## Product Change Notification / JAON-27XQGL571

CCB 4470 Final Notice: Implement new carrier tape and reel for selected Atmel products available in 64L TQFP (14x14x1.0mm) package at ASE9 final test site.

**CCB 4470**  
**Pre and Post Change Summary**  
**PCN# JAON-27XQGL571**

# Carrier Tape Dimensions

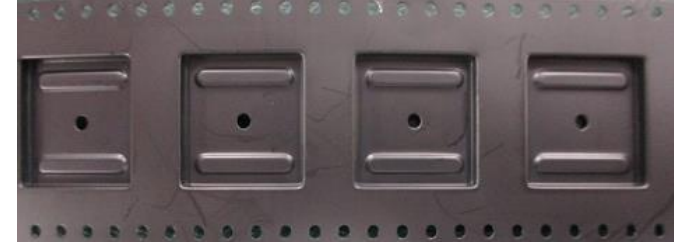
A0: **17.0** B0: **17.0**

K0: **2.10** K1: **1.40**

A0: **16.5** B0: **16.5**

K0: **1.90** K1: **1.55**

# Reel Dimensions

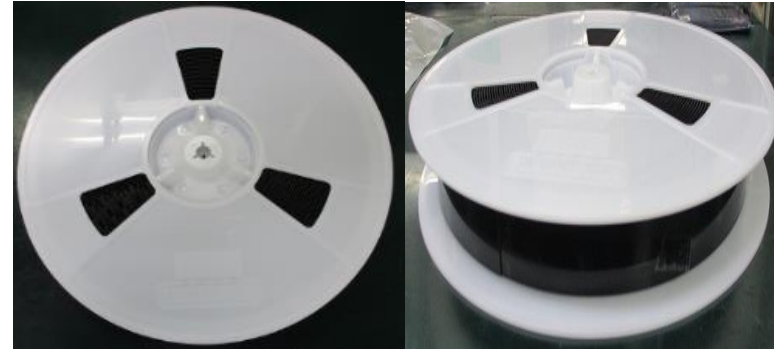
Reel Diameter: 330 mm  
Reel Hub size: **181.5 mm**

Reel Diameter: 330 mm  
Reel Hub size: **100 mm**
